**Regulation No. XXX**

**Uniform Provisions Concerning the Approval of Mechanical Coupling Components for  
Agricultural Vehicles**

Testing: Mechanical coupling devices for agricultural vehicles

Last updated: 21 July 2011

Figure 20 – Hitch ring 50

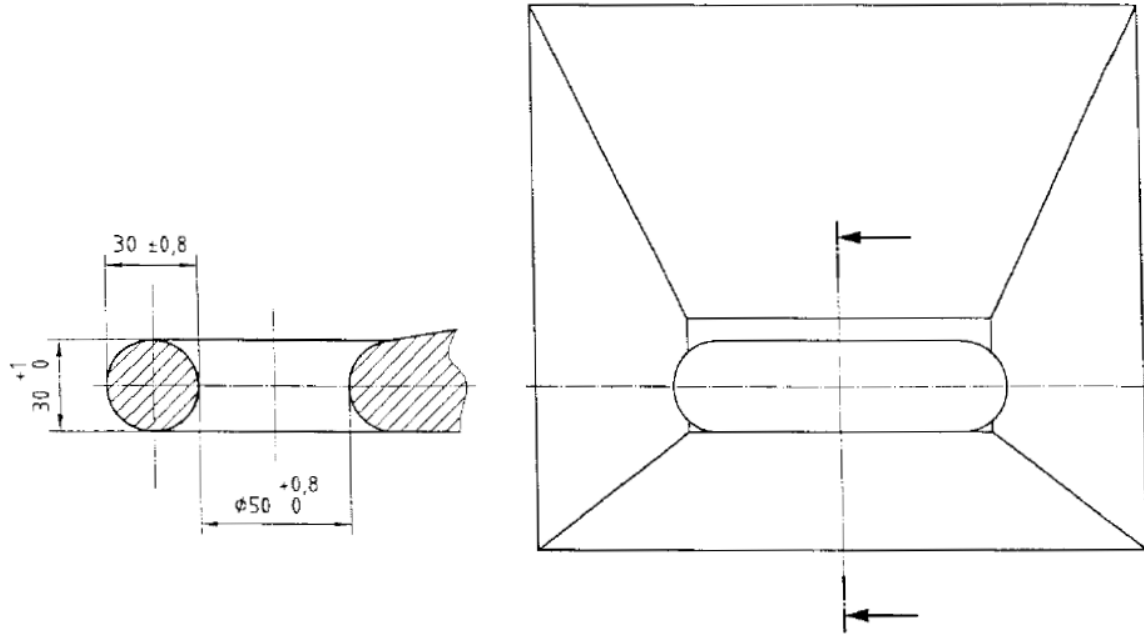
All coupling rings of Class d3 shall be designed so that they are able to satisfy the tests given in **xx** of annex 6. **There is no point for d3.**

Coupling rings of Class d3 shall conform to Figure **xx** in external shape and external dimensions.
